RECEIPT DATE: 8/11/23 **ONSITE SEWAGE DISPOSAL SYSTEM**

PROPERTY ADDRESS: 5236 Green Bridge Road

**From:** Silvast, Zackary  
**Sent:** Thursday, July 13, 2023 5:30 PM  
**To:** Luke Groom  
**Cc:** Paul Cavanaugh  
**Subject:** regarding 5236 Green Bridge Road OSDS revision comments

**SEPTIC SYSTEM INSTALLATION PLAN**  
**5236 GREEN BRIDGE ROAD**

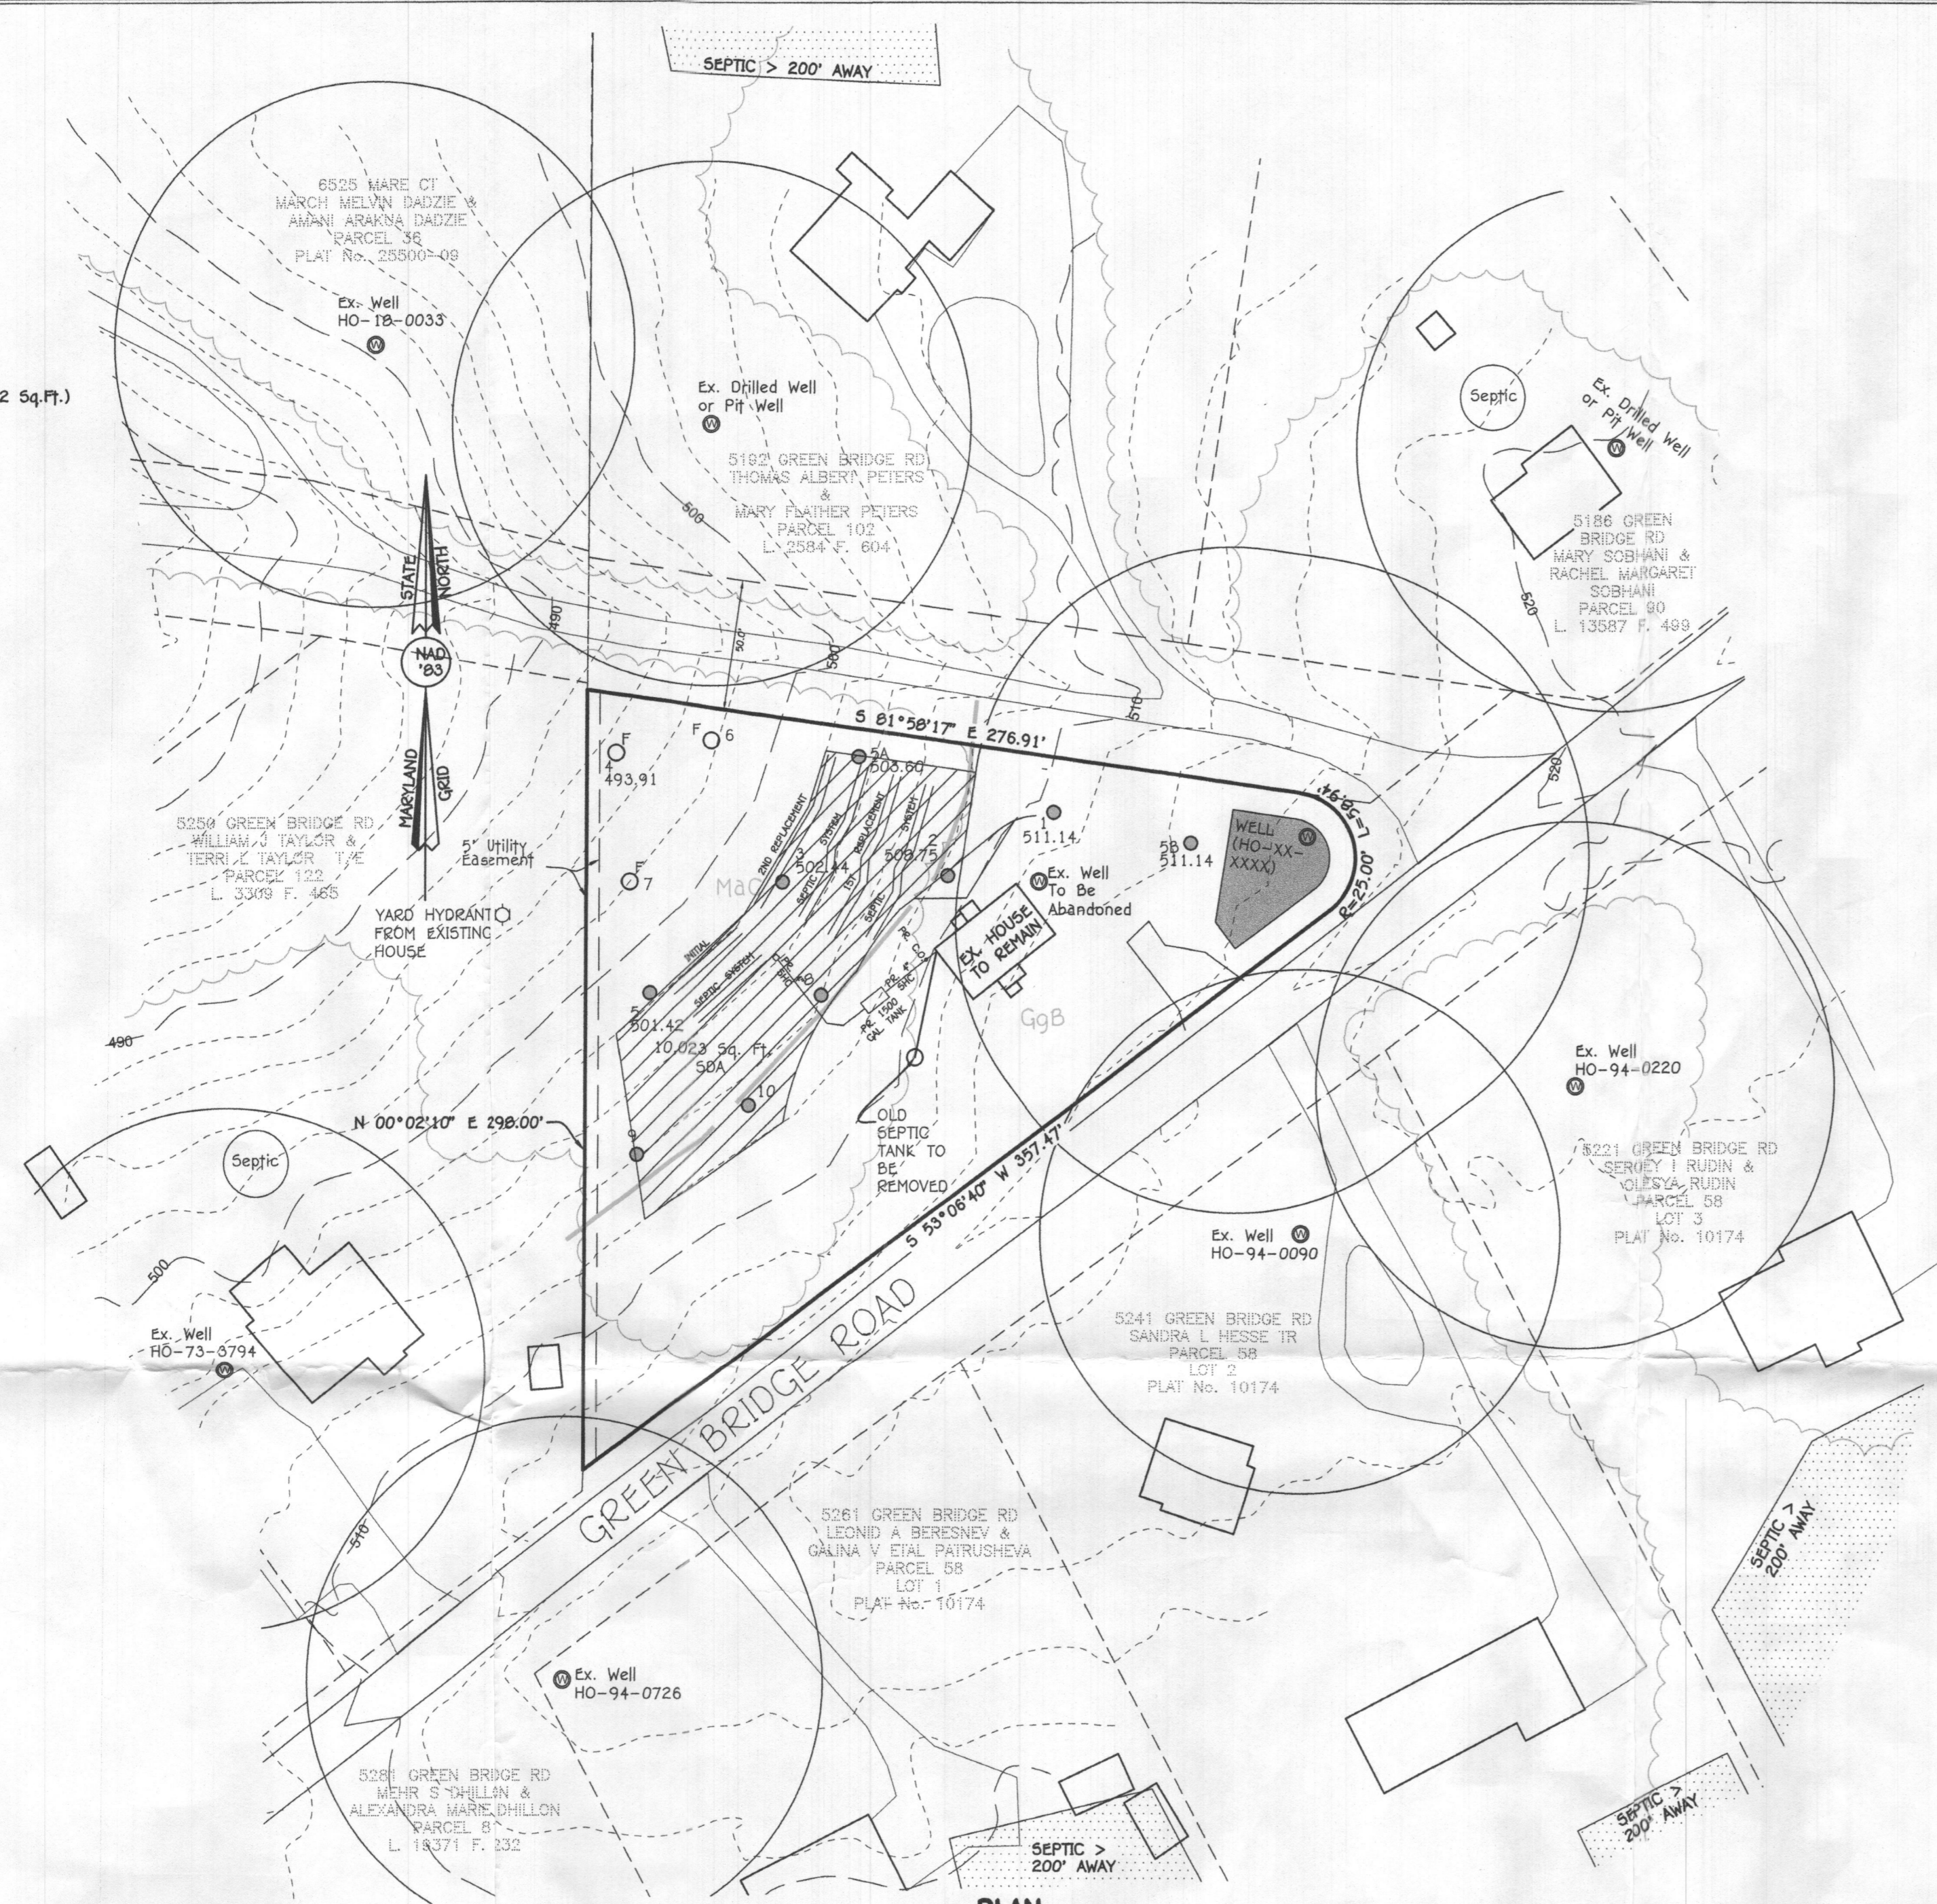
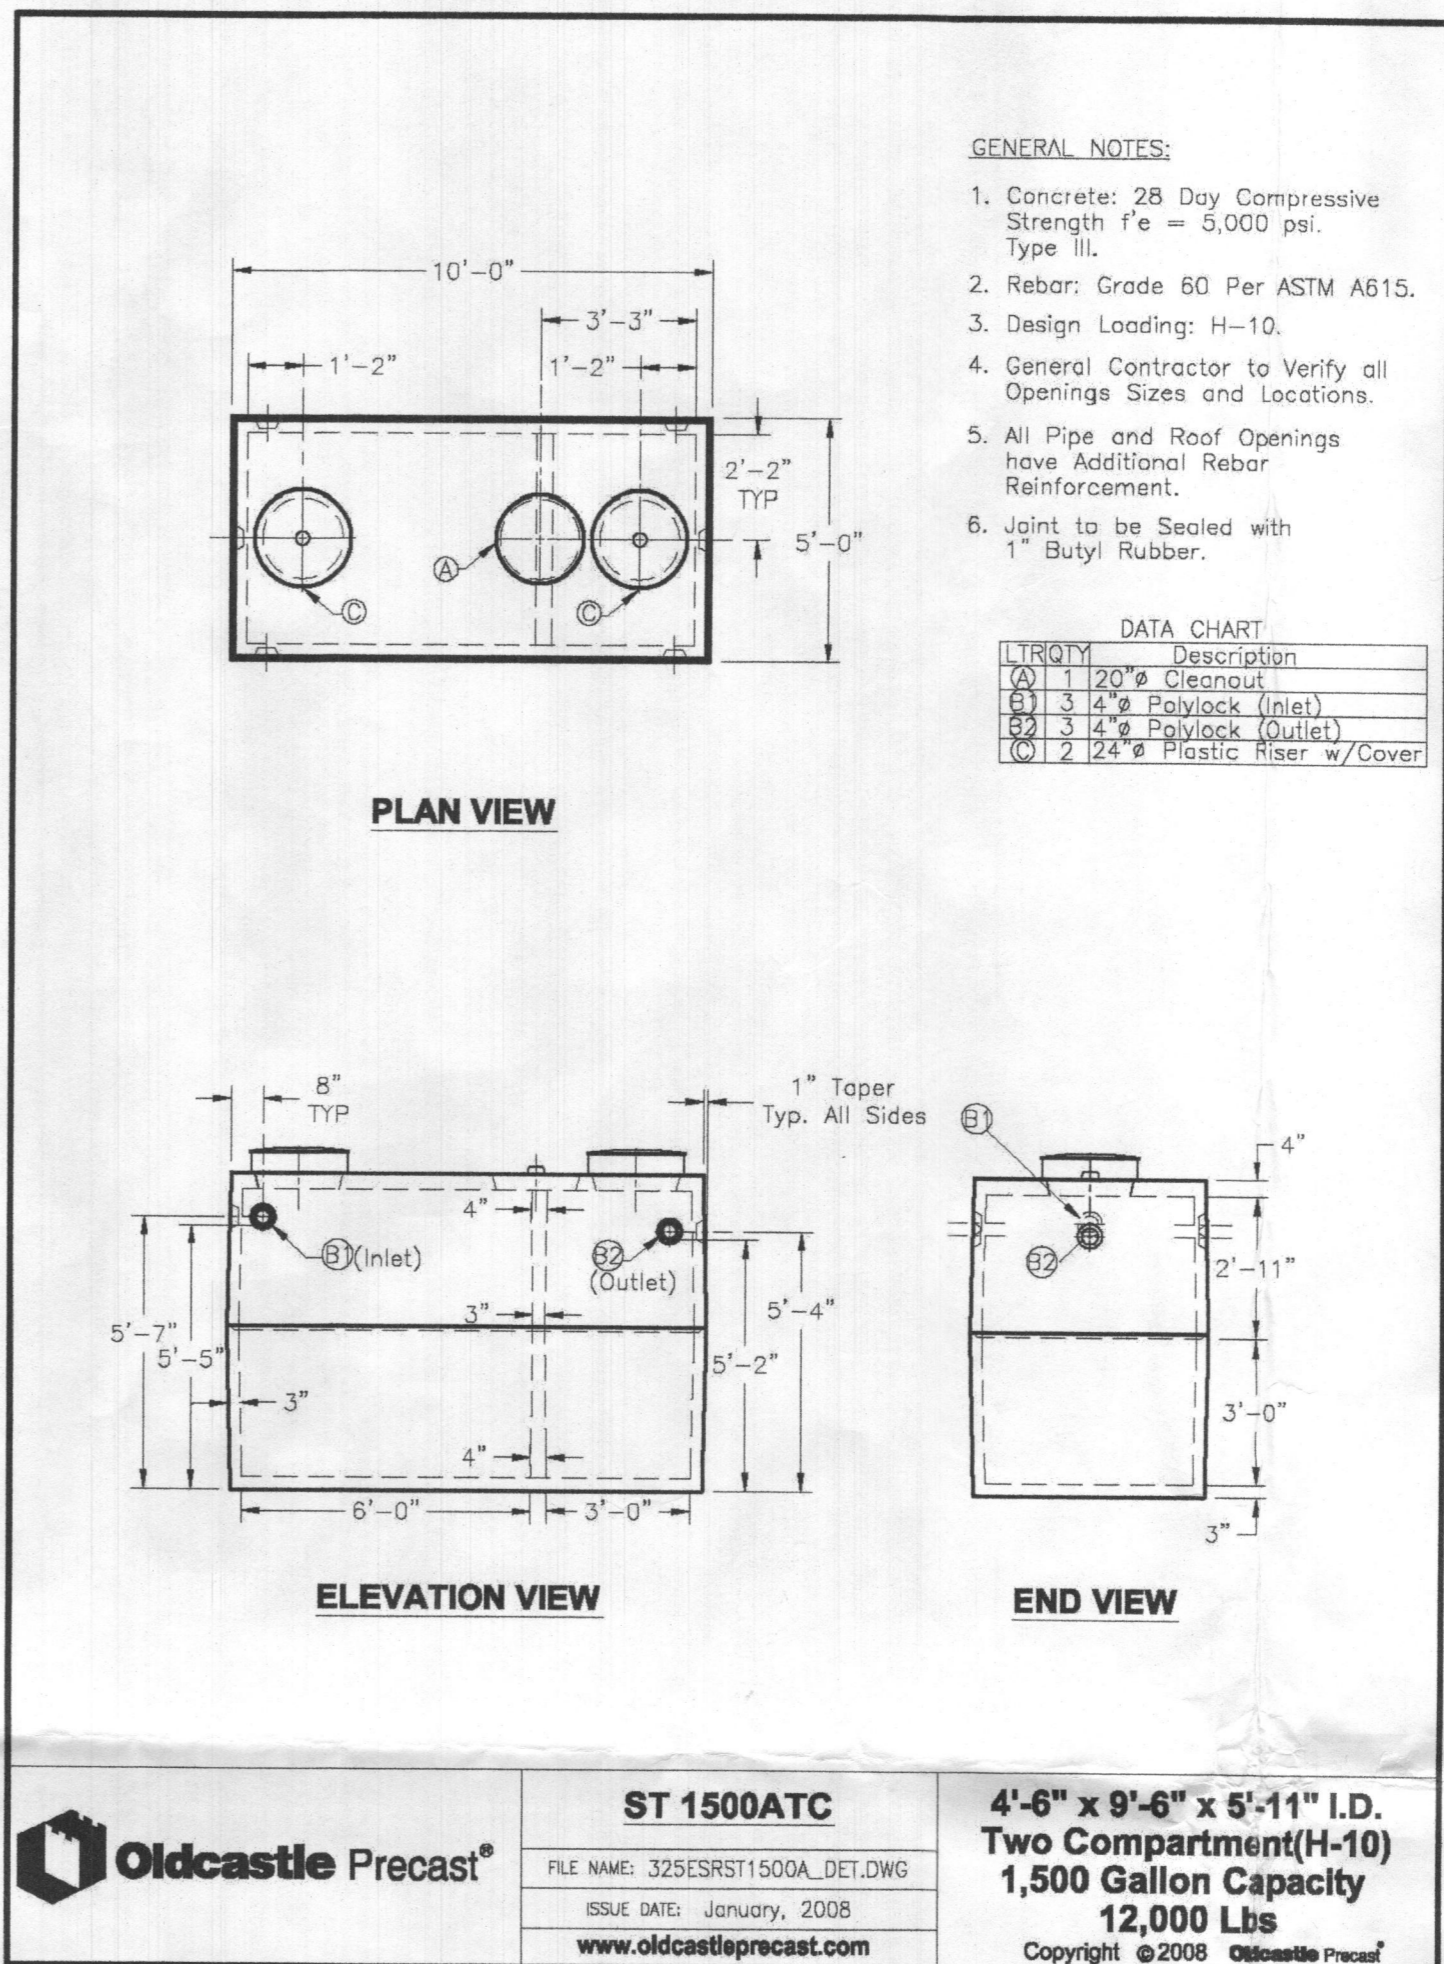
Has this new well been drilled and the old well abandoned? I cannot approve a OSDS plan until that has been completed.

1. Trenches need to be as linear as possible while maintaining natural contours.
  - a. NO wiggle worm trench drawings.
2. Scale needs to be adjusted, actual site plan is way too small use 1" = 40'.
3. Note 7 is not acceptable, this needs to be accounted for in the design and shown on the plan.
4. There's pump tank details and elevations but no pump tank shown on the plan?
5. Trench detail is off and upside down and not fully labeled.
  - a. 4.5' of stone 3.5' earth cover.
  - b. Need to show effective depth in profile.
6. What does note 6 mean? Is it applicable?
7. For septic system calculations.
  - a. Initial, use 35' lines.
  - b. For the two replacements, use 63' lines.
